Accessibility Design Review Report

Project Title: Light Horse Interchange – Warehouse 3B Mod.
475 Ferrers Rd, Eastern Creek

Job Number: 22342

Report Version: 22342_ADR_SSDA_Lot3B_v1.1

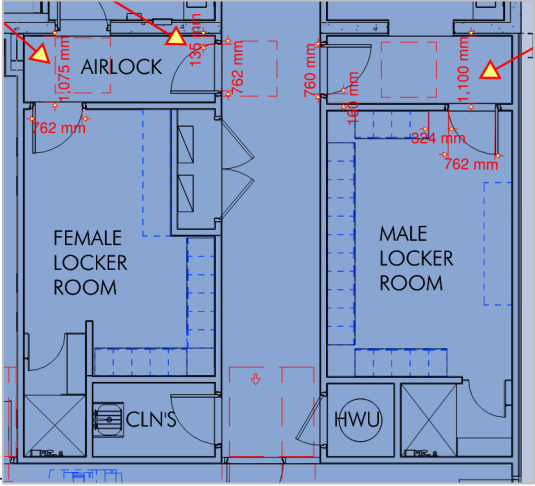
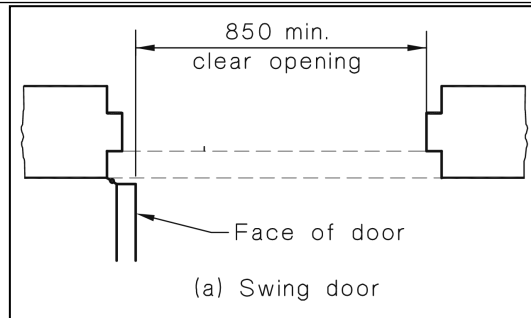
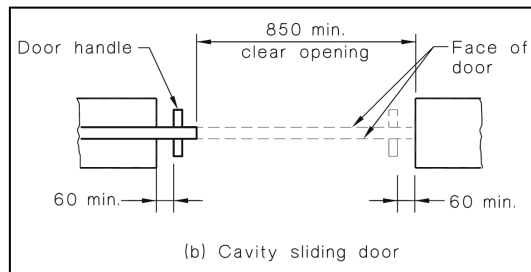
Ensure hardware clearance of 60mm either side is provided to sliding doorways in the open/closed position.

Ensure the prescribed doorway latch-side clearance is provided to the active leaf of all common area doorways used by the occupants in accordance with AS1428.1-2009.

Ensure control buttons and card readers are located ≥ 500 mm from an internal corner, over a level surface/landing and installed at a height between 900mm - 1250mm.

Ensure level transitions or compliant ramps with landings are provided between internal and external areas (refer to mark-up options).

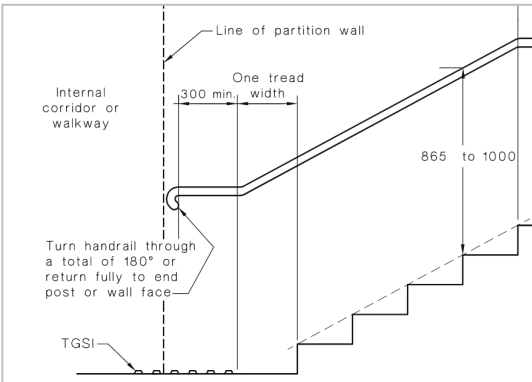
All pathways require a minimum unobstructed width of 1000mm. Pathways shall not include impediments such as steps or turnstiles without an accessible alternative provided.

and other circumstances may require a greater width than 1000mm. <u>Design Detail:</u> Verification of slip resistant surface finishes on all accessways should be provided prior to OC sign off. It is recommended to refer to HB-198 for area ratings and test in accordance with AS4586-2013. Ensure any tracks/grooves (including for water shedding or sliding doors) and grate slots/holes are no greater than 13mm wide (depending on orientation) and are recessed to maintain flush/level pathways.	
--	--	--

Cl. D4D3: Access to Buildings

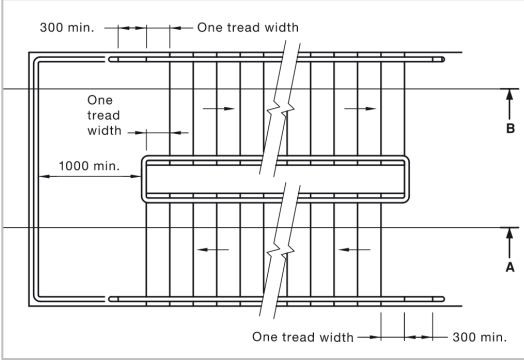
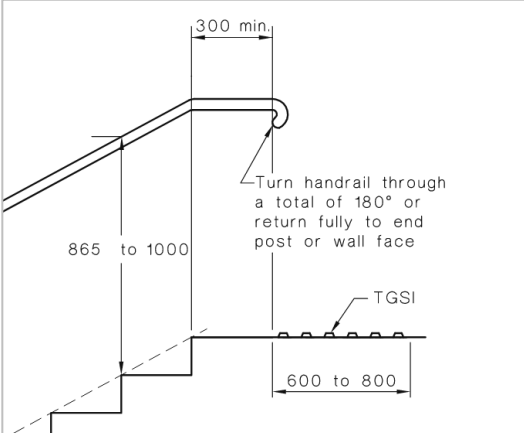
DtS Provision	Comment(s)/Recommendation(s)	Status
An accessway must be provided to a building required to be accessible – • from the main points of pedestrian entry at the allotment boundary; and • from another accessible building connected by a pedestrian link; and • from any required accessible carparking space on the allotment. In a building required to be accessible, an accessway must be provided through the principal pedestrian entrance, and – • through not less than 50% of all pedestrian entrances including the principal pedestrian entrance; and • in a building with a floor area more than 500m², a pedestrian entrance which is not accessible must not be located more than 50m from an accessible pedestrian entrance. except for pedestrian entrances serving only areas exempted by D4D5.	Compliance is readily achievable with design development and/or specification to BCA & AS1428.1-2009 at the Detailed Design Stage. <u>Allotment Boundary</u> 2x pedestrian entries appear to be provided for Lot 3 (1 per warehouse). The major considerations are providing sufficient circulation space to the gates and shallow gradients (1:40). Any walkway/ramp landings proposed on council footpath must have a gradient of 1:40 in all directions. <u>Accessible parking</u> Accessible parking is proposed adjacent to each office portion and the Cafe. Kerb/step ramps will be required if they are not on the same grade as the footpath/building. <u>Other accessible buildings</u> Plans do not appear to indicate any pedestrian link within the site between Warehouse/Office 3A & 3B. <u>Principal Pedestrian Entrances (Building)</u>	CoC/ DD

Access appears to be proposed through the Principal Pedestrian Entry of each office building. Further details will need to be provided for review at a more detailed design stage regarding access through pedestrian entries to the warehouse etc...	
--	---	--

Cl. D4D7: Signage

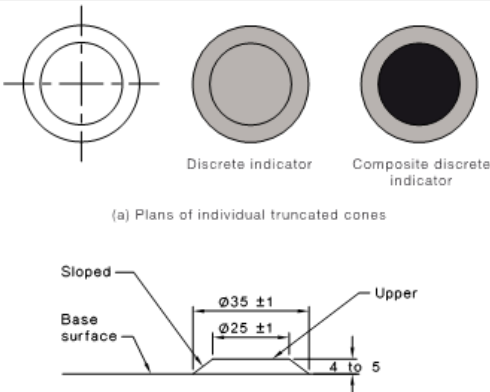
DtS Provision	Status
In a building required to be accessible signage complying with Spec. D4D7, AS1428.1-2009 and incorporating the appropriate recognised symbol (as appropriate) for persons with disability must be provided as follows — • braille and tactile signage must identify each sanitary facility and space with hearing augmentation; • braille and tactile signage must identify each door required by E4.5 to be provided with an exit sign and state “Exit” and “Level” followed by the floor level number; • signage must be provided within a room containing a hearing augmentation system identifying; the type of system, the area covered within the room and if receivers are being used and where the receivers can be obtained; • signage must be provided for accessible unisex sanitary facilities to identify if the facility is suitable for left or right handed use; • signage to identify an ambulant accessible sanitary facility must be located on the door of the facility; • directional signage where a pedestrian entrance is not accessible. • directional signage where a bank of sanitary facilities are not provided with an accessible sanitary facility. A design compliance certificate should be obtained from the signage designer/contractor to confirm compliance with the relevant provisions of the BCA and Australian Standards.	DD
